**Re: Docket No. LC 66 – Sierra Club Comments on Portland General Electric’s  
2016 Integrated Resource Plan [CONFIDENTIAL]**

LC 66

2016 Integrated Resource Plan

**SIERRA CLUB COMMENTS  
[PUBLIC VERSION]**

**Figure 1: Proxy Resources by Portfolio (% of new capacity)**

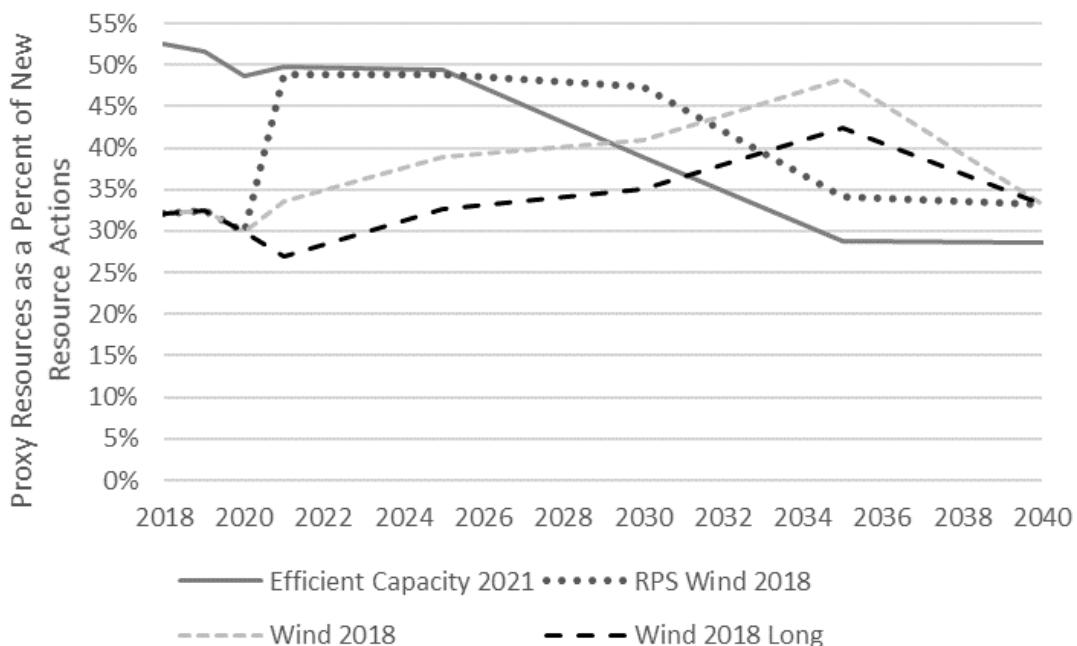
As discussed above, PGE developed portfolios of pre-determined resource mixes which generally meet energy and capacity obligations while also complying with the Oregon RPS. PGE then tested these portfolios under “futures” to determine the NPVRR under different conditions—focusing on variations of carbon, natural gas, and load forecasts. However, while the mix of specific resources changes between portfolios, the bulk of PGE’s new capacity builds is comprised of proxy resources. The prominence of proxy resources varies from portfolio to portfolio, as PGE used “generic” capacity to supply any resource need that was left over after it hand-picked specific resources to add. However, in many cases these resources come to represent a significant fraction—over a fifth—of PGE’s resource fleet, and approximately half of its near-term resource decisions, over the course of the planning horizon—shown in Figure 1.

PGE leaves the Commission with two unsatisfactory possibilities, both of which may be true to some extent. One possibility is that these resources are true “proxies” and PGE does in fact intend for *any* cost-effective mix of resources to be able to supply the associated energy and capacity. In this case, PGE is essentially asserting that, as soon as four years from the present, the composition of a sixth of its total resource mix will be a complete mystery. Will this portion

The other possibility is that PGE does, in fact, have a strong sense of what resources will fill these gaps—and that it will be an NGCC. PGE chose to model these resources as new gas-fired units, rather than contracts, hydro, or any other type of resource. PGE's apparent capacity need is in 2021, and new NGCCs typically require four to five years to permit and construct. If PGE plans to acquire a new NGCC, it does not have time to wait until the next IRP cycle to demonstrate the cost effectiveness of this specific resource. As such, PGE has clearly stated its intent to procure a new resource as a result of this IRP, without explicitly identifying what resource it intends to procure. By deferring any explicit resource decisions until an RFP, PGE has effectively denied stakeholders the opportunity to be involved in PGE's actual resource planning.

**Figure 3: NPVRR Costs of Action Plans Relative to Preferred Portfolio (\$millions)**

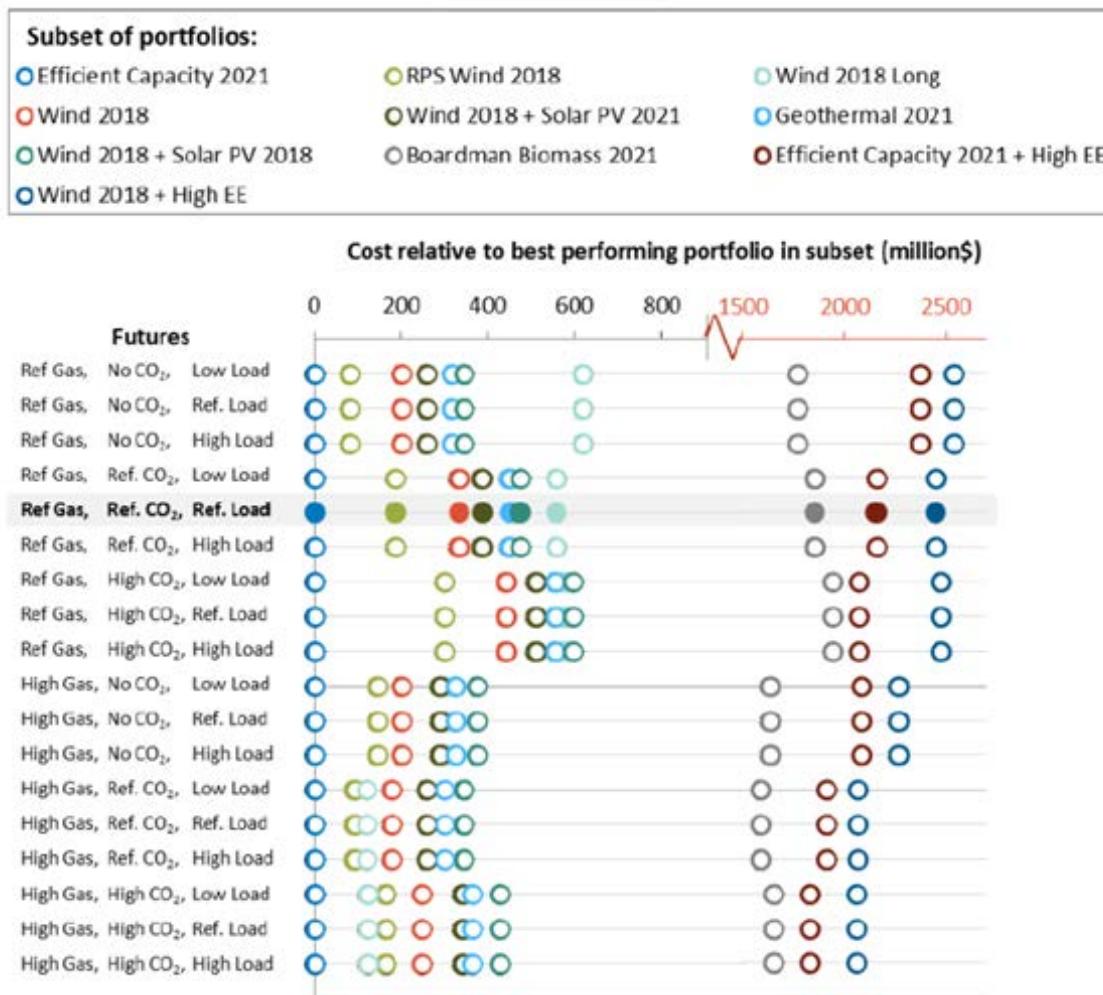
This result shows that the load levels do not influence the choice of portfolio. This is counterintuitive as one would expect resource procurement to change with load expectations. However, PGE did not vary the amount of capacity procured with load. The Company claimed that "the load sensitivity is intended to identify economic risks *associated with varying levels of exposure to market energy* for a given portfolio."<sup>19</sup> The results merely tell us that if PGE procured a fixed level and mix of capacity, it would buy more (and sell less) on the market if load were higher, or buy less (and sell more) if load were lower. This is not surprising but also not informative. This result emphasizes the impact of PGE's market assumptions on its portfolio results, the scoring thereof, and—ultimately—its selection of a preferred portfolio.

**Recommendation:** PGE should evaluate specific resource options throughout the entire analysis period, including gathering sufficient data and allowing capacity builds to change with load expectations.

**Figure 4: Historical EE Savings vs. Projected EE Savings in PGE 2016 IRP (% of annual sales)**

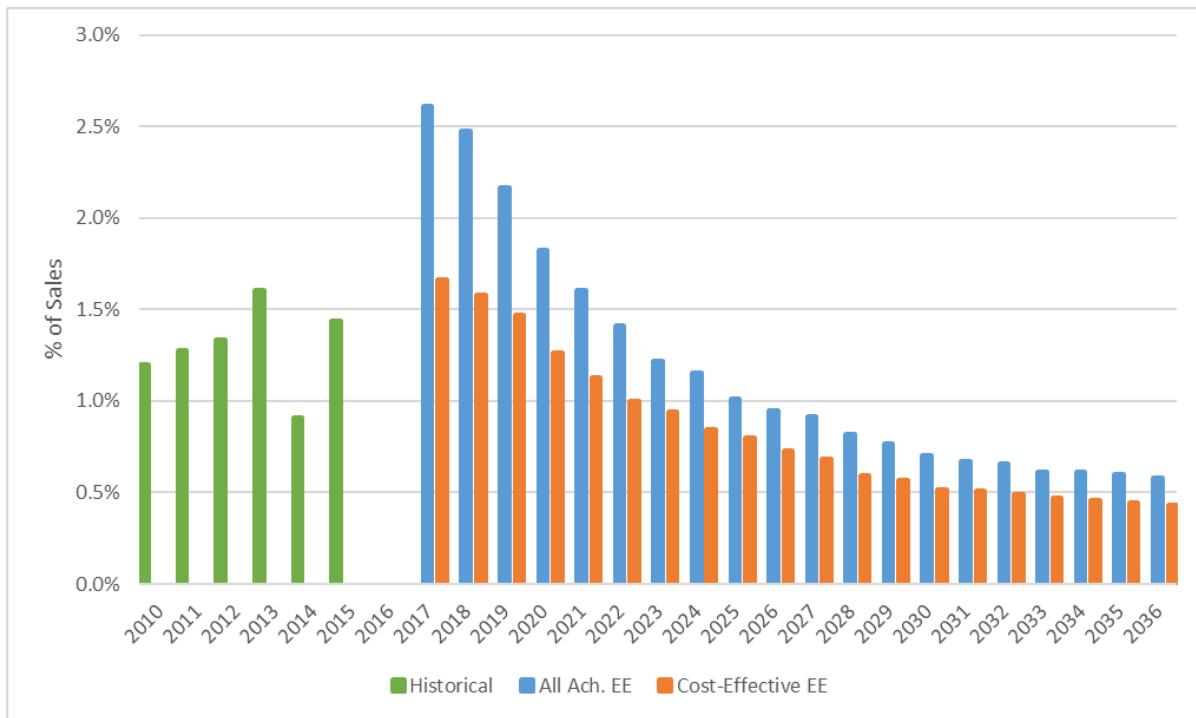
Energy efficiency programs under PGE's service territory are handled by the ETO, Oregon's statewide third-party EE program administrator. ETO has recently achieved about 1.5 percent annual savings, as shown in Figure 4 below.<sup>45</sup>

However, PGE's IRP (which adopted ETO's recent analysis) predicts that future energy savings will substantially decline over time. Shown as "cost-effective EE" above, PGE expects a similar level of savings in 2017 at about 1.7 percent but this declines to less than 0.5 percent by 2033. The all achievable potential ("All Ach. EE" above) includes the level of EE that is technically possible yet not all of this is cost-effective. These declining savings projections are not supported by any historical evidence in the region. For example, utilities in the Northwest together have increased energy savings year by year since 1978 (shown below).<sup>46</sup>

**Figure 5: Historical Energy Savings Achievements in the Northwest Region (aMW)**

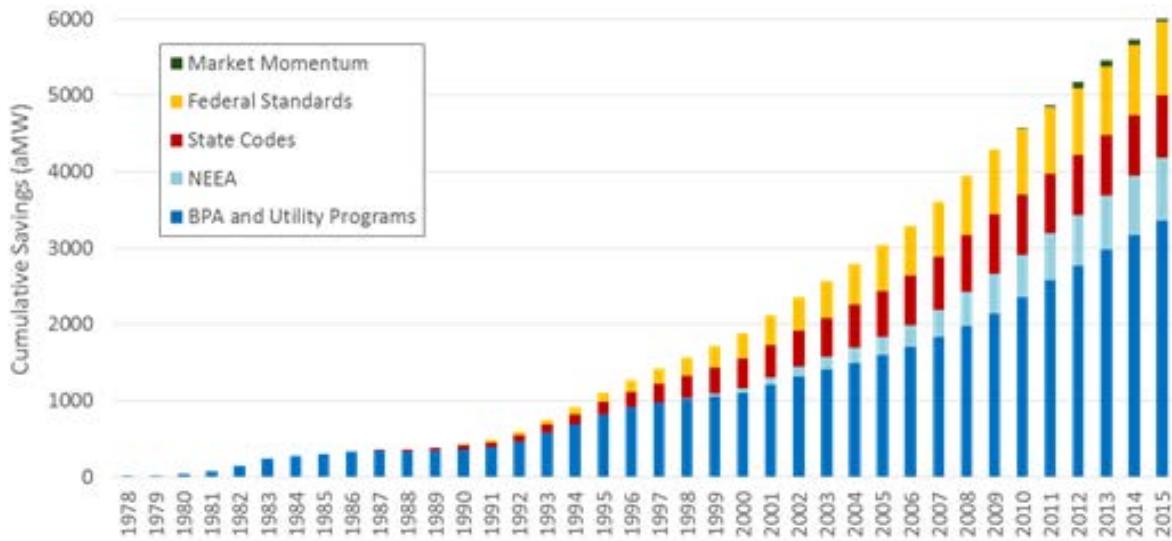
The Pacific Northwest shows no sign of shedding EE savings in the future. Despite the region's impressive efforts to tap into the region's EE potential already, the latest NWPCC power plan in 2016 has found an additional 4,300 average MW (aMW) potential over the next 20 years.<sup>47</sup> Additional EE has the potential to avoid or at least delay construction of new generating facilities. Unfortunately, the rigid and inflexible structure of PGE's analysis does not allow for this possibility and, if it did, the effect would be muted by the faulty assumption that EE savings will rapidly diminish.

**Figure 6: Projected Costs of Saved Energy (cents per kWh) vs. Savings (% of annual sales)**

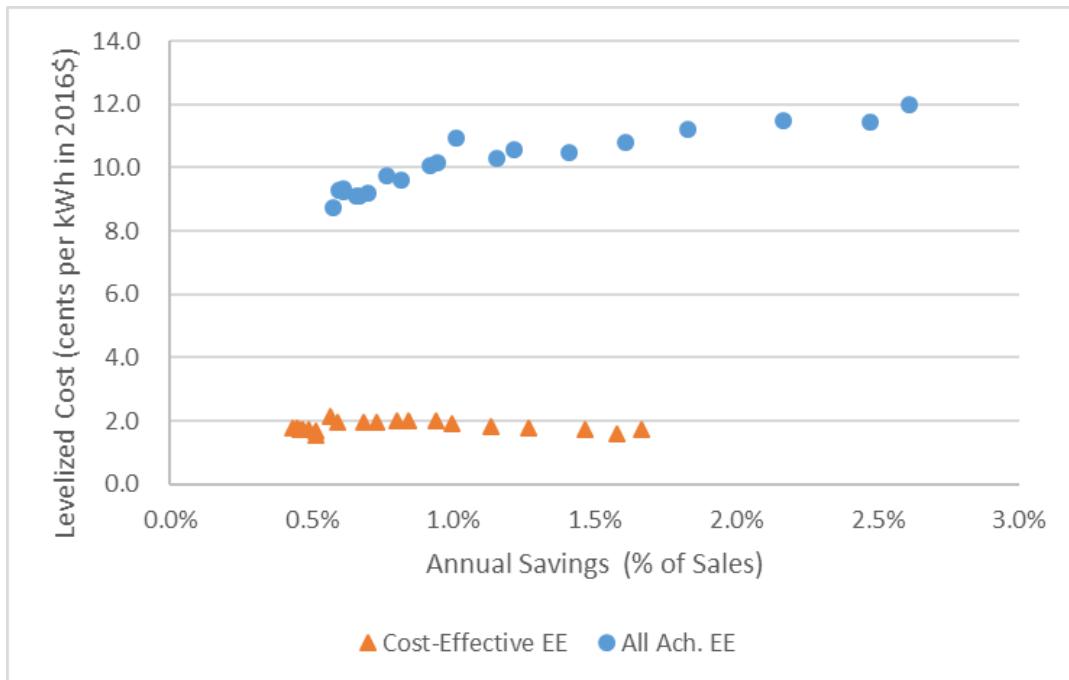
Based on the program costs and savings data provided at Table 6-1 of the IRP, we estimate that the levelized total resource cost of the efficiency programs over the lifetime of the measures is about 2 cents per kWh for cost-effective EE, and 9 to 12 cents per kWh for the all achievable EE.<sup>48</sup> These levelized costs are shown in Figure 6 below where we compared the cost of saved energy with the annual projected savings estimate as a percentage of sales.

PGE is clear that these costs are “total resource costs,” which include both program costs and out-of-pocket participant costs. However, the cost estimate for all achievable EE is likely too high. This projects 2 to 2.5 percent savings per year in the first few years and diminishing annual savings over time to about 0.5 percent (as shown in Figure 4). Historical evidence suggests that aggressive programs at similar savings levels will not increase program costs per kWh savings and can maintain these high levels of savings over multiple years. For example, Massachusetts and Rhode Island have achieved 2 to 3 percent annual savings in recent years, yet their program costs have been very stable at around 3 to 4 cents per kWh.<sup>49</sup> The total resource costs—which include participant spending—for these two states are about 4 to 6 cents per kWh.<sup>50</sup> This implies that the cost estimates for the all achievable EE are likely overstated.
